Special Bulletin

SP17-308A

NYCT COMPRESSOR DOOR UPPER HINGE REPLACEMENT

Prevost vehicles

FIG.4 NEW UPPER HINGE

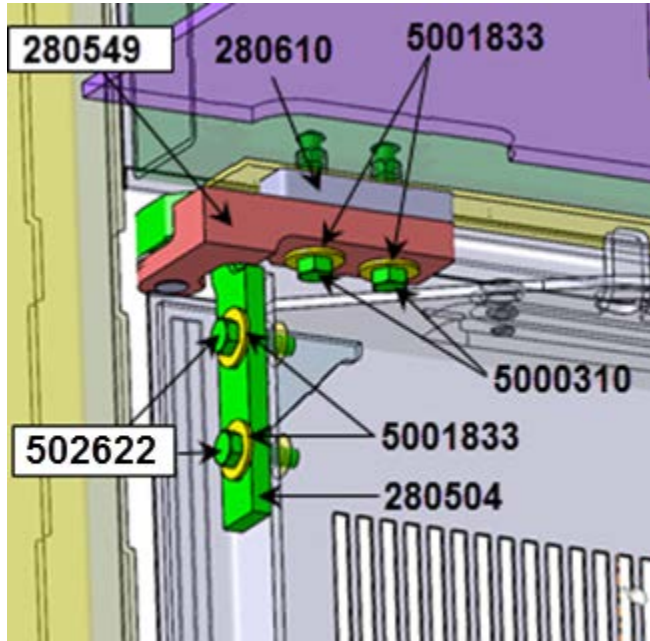
On the vehicles affected by this bulletin, the upper compressor door hinge must be replaced by a new improved hinge providing better door retention.

4. Install the new upper hinge (parts **280504**, **280549** & **280610** in kit Fig.4) making sure that:
 - New M6 bolts and washers (**5000310** & **5001833**) are used at the upper (vehicle structure) mounting points (Fig.4).
 - New M6 bolts (**502622** & **5001833**) are used at the door mounting points (Fig.4).
 - A new plastic bushing **284607** is installed at the pivot point (Fig.5).
 - The door is fully supported by the *lower hinge* and not slightly lifted-up by the lift table so there is no gap between parts at the lower pivot point (Fig.6).
 - There is no gap between the upper and lower part at the pivot point of the upper hinge (Fig.7).
 - The four M6 bolts are torqued to **68 lb-in** (apply blue Loctite 242 or equivalent medium strength thread locker on all fastener threads (Fig.8)).
